Re: ***Addendum No. 3***
WWTP & LS Improvements
Contract A – WWTP Improvements
Contract B – Brooklyn Street LS Improvements
City of Port Clinton, Ohio

Date: October 27, 2026

CITY OF PORT CLINTON, OHIO
PORT CLINTON WWTP & LS IMPROVEMENTS
OTTAWA COUNTY OHIO

PROJECT NO: 33943
DRAWING NAME: 00E-04
SHEET 27 OF 31

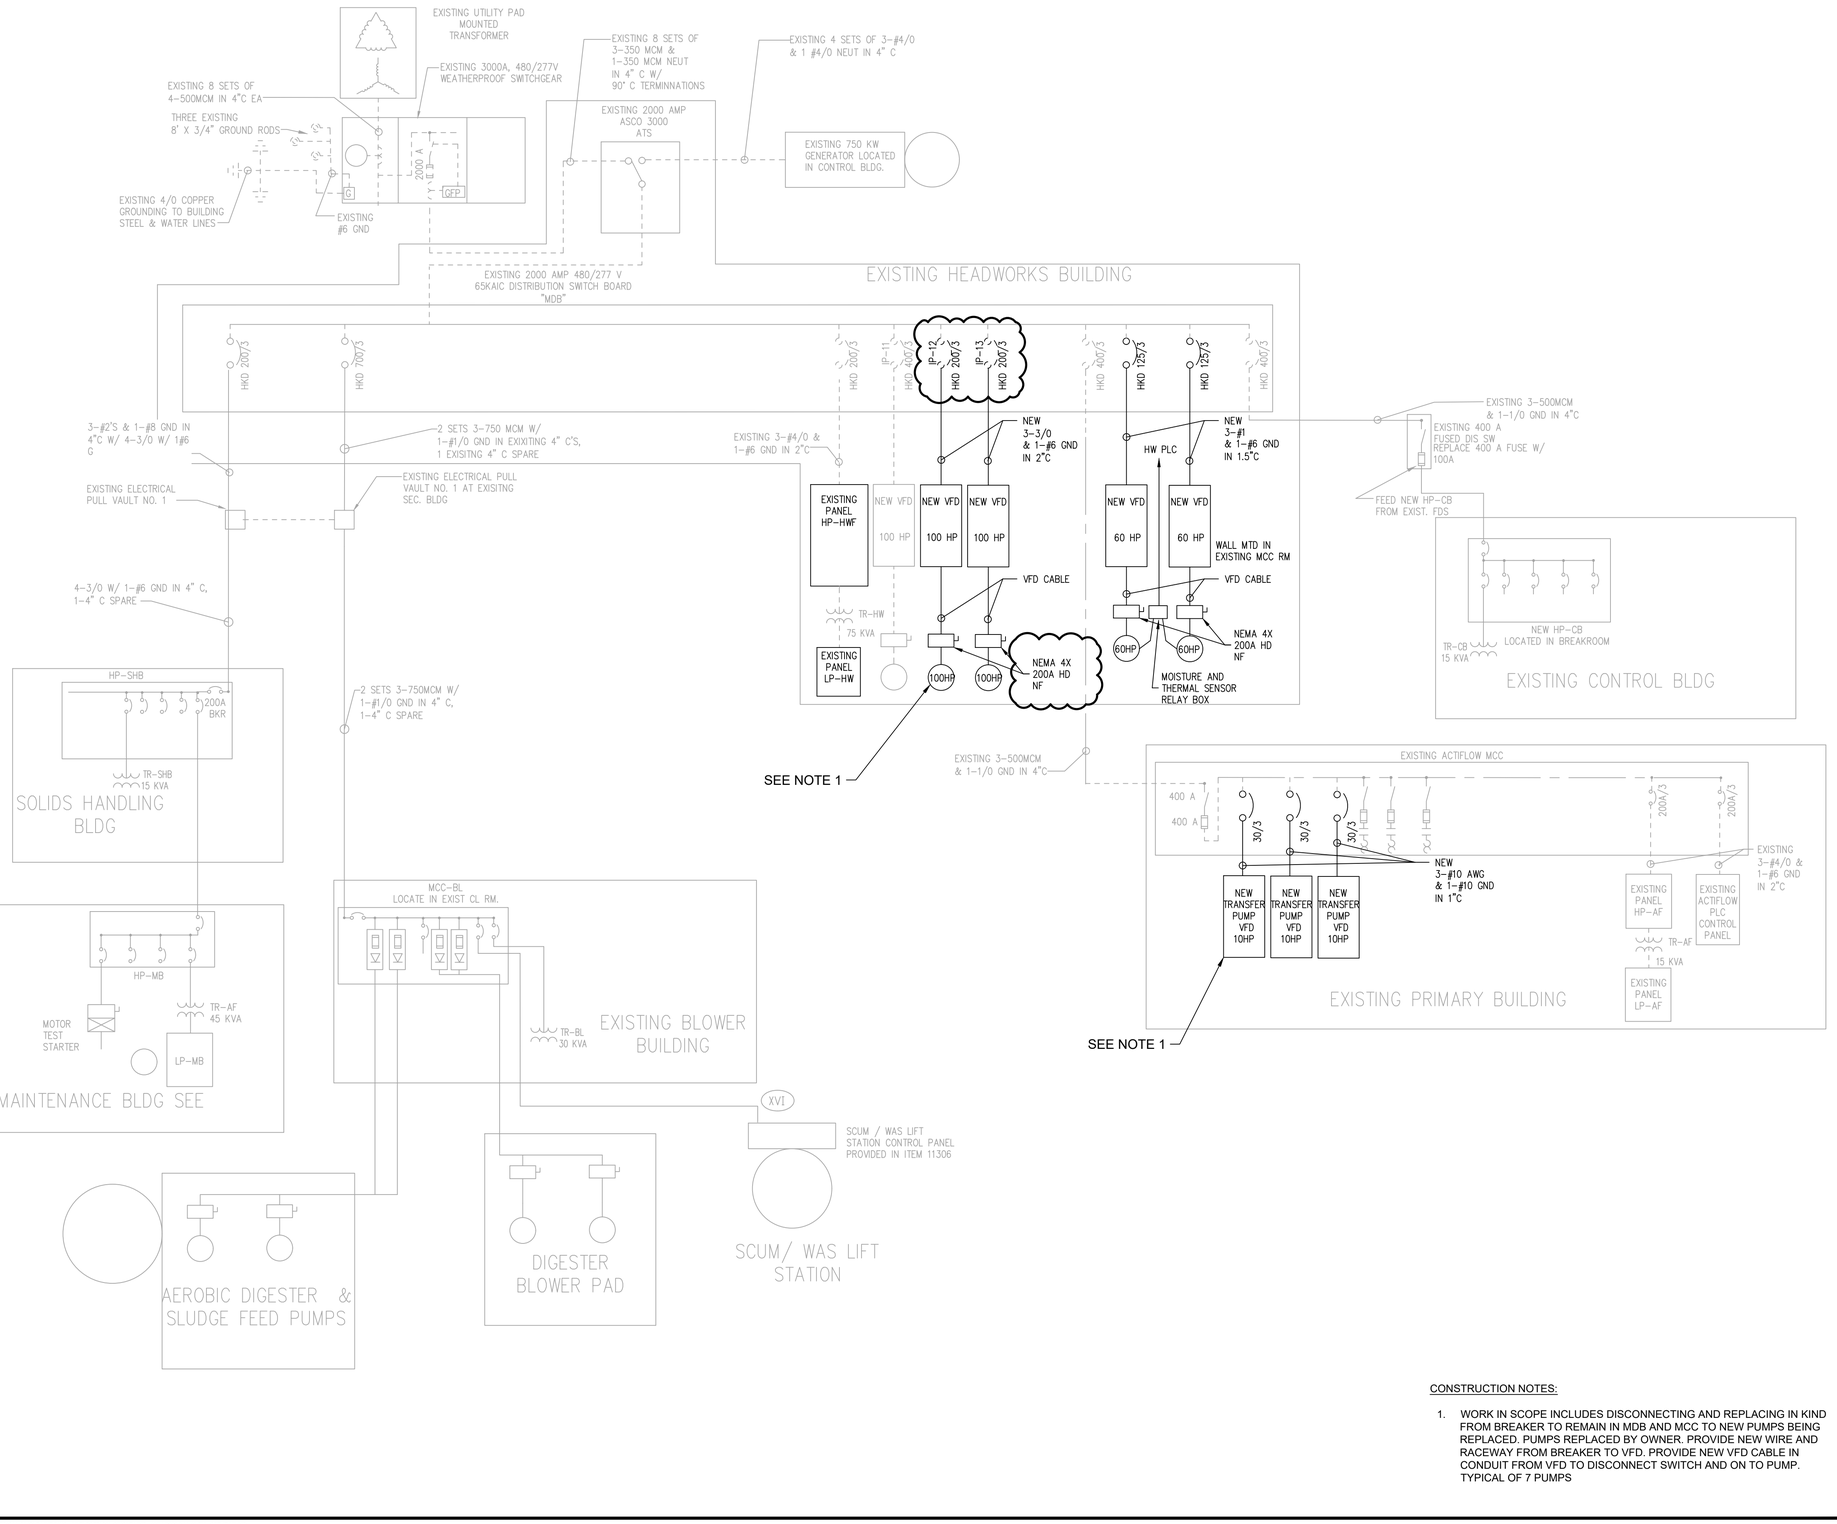
Q1. Should the new disconnects for the 100 HP pumps be 200A?

Q2. Per drawing 00E-04 seven (7) total new VFD's for the various pumps at the WWTP site are shown. Can you please advise who is to provide the VFD's and more details on the VFD's?

Q4. Is the conduit and wire being replaced between the (3) 10 HP VFD's and the secondary pumps?

A4. As described in Construction Note No.1 on Sheet 00E-04, new wire and conduit from source to load is all new.

A1. Yes, see revised Revised Plan Sheets 27/31 and 28/31 enclosed in this Addendum.

A2. The VFD's will be procured and installed as part of the Contract A Scope of Work. The design intent is to replace in-kind from the breakers to new pumps (pumps procured and installed by Owner); new VFD's that will maintain the same operational functionality and level of controls/service as the existing units, including the current Bypass Capability. Refer to Specification Section 26 29 23 – Variable Frequency Motor Controllers, enclosed with this Addendum for more details.

PROJECT NO:	
33943	
DRAWING NAME	
20E-01	
SHEET	OF
28	31

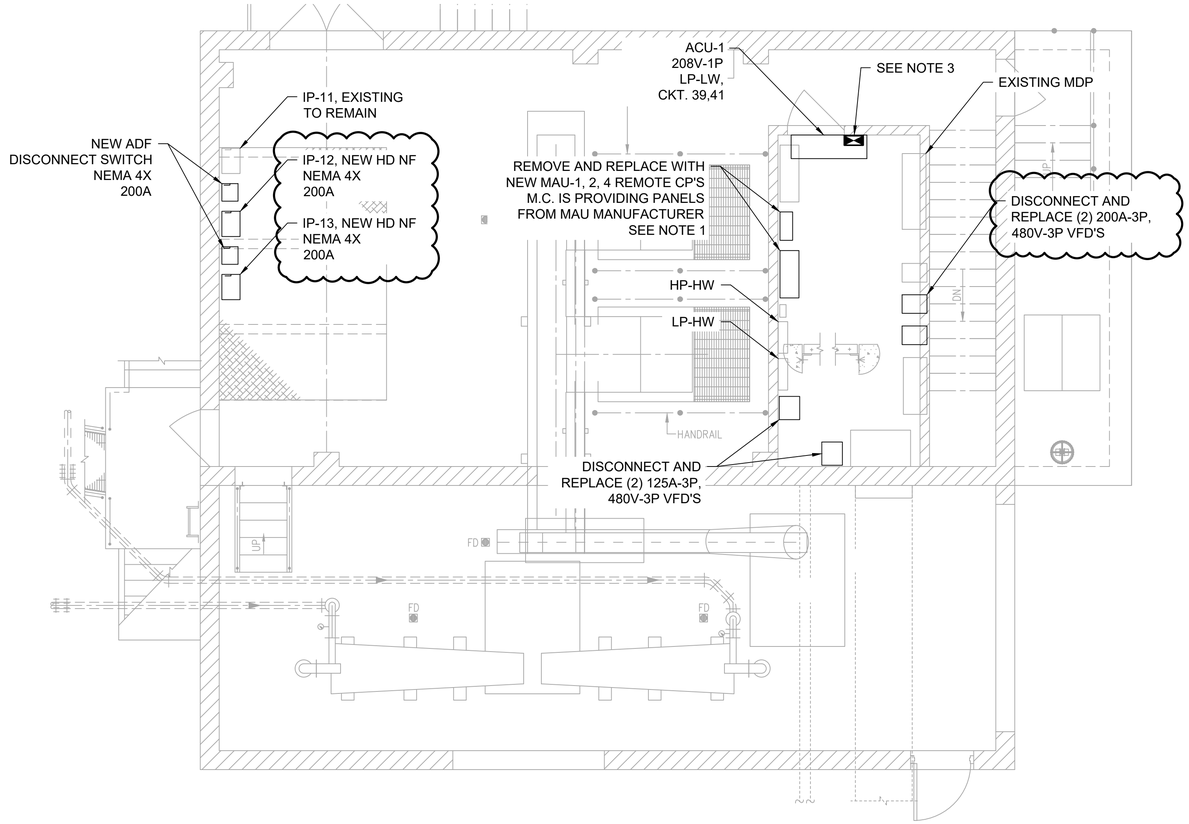
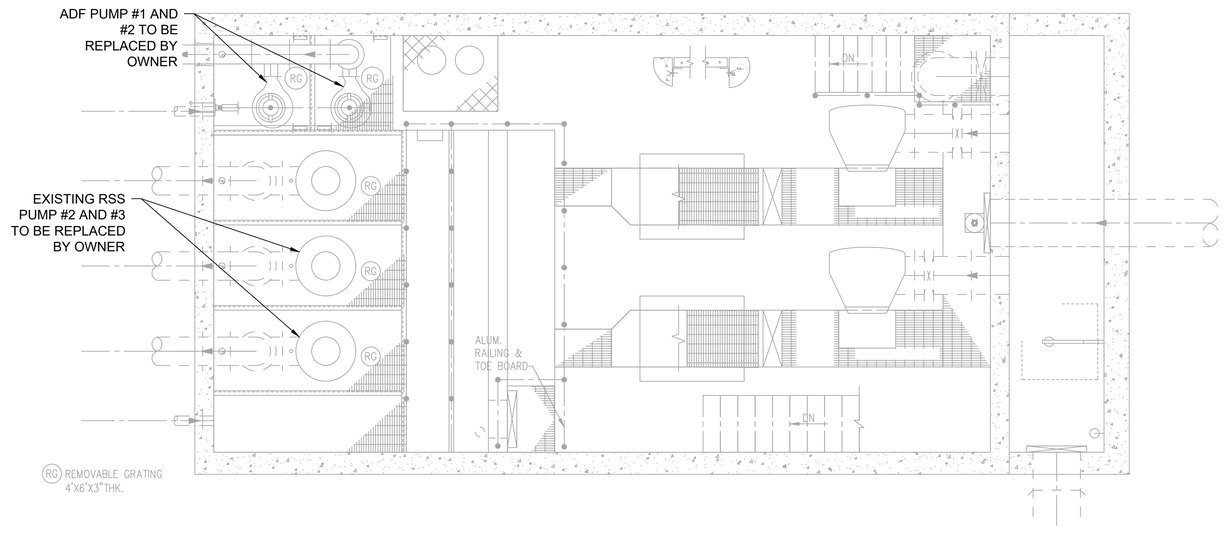
Q5. Can further details be provided for the work associated with Construction Note No.1 on drawing 20E-01, in relation to the duct detectors?

Q8. Can further details be provided for the work associated with Construction Note No.2 on drawing 20E-01?

Q9. Is any SCADA programming work required in relation to the work described under Construction Note No.2 on drawing 20E-01?

A5. Current design is code compliant. Contractor is only to verify if the current equipment utilize similar duct detectors. If so, Contractor shall notify the Owner for coordination work to be completed by the Fire Alarm Vendor outside the scope of work for this project. No work related to any fire alarm system is included in the scope of work for this project.

A8. Contractor is to verify if the current units have the monitored. If so, Contractor will reconnect monitoring points to the new unit, and verify signal is captured.

A9. No rewiring or programming is expected unless the existing switches, wiring or associated components are damaged during the installation of the proposed units.
